MODEL: 2008 CONCOURS™ 14/14 ABS (ZG1400A8F/L, ZG1400B8F/L)
TITLE: SADDLEBAG LATCH REPLACEMENT

RECALL

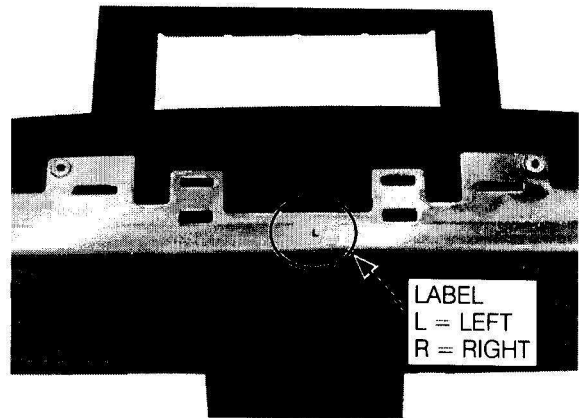
- Match the label on the latch assembly to the appropriate saddlebag.
L: left side R: right side

- Install the new latch assembly on the saddlebag using the screws and washers removed previously and tighten the screws.

Torque

0.6 N-m (0.06kgf-m, 5.3 in-lb)

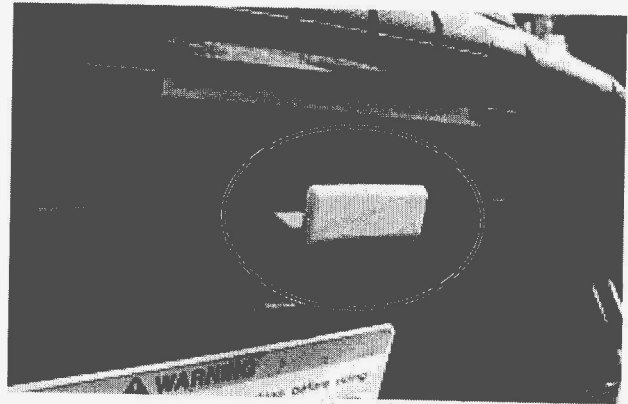
The latch color will serve as repair verification.

OLD: RED . . . NEW: ORANGE
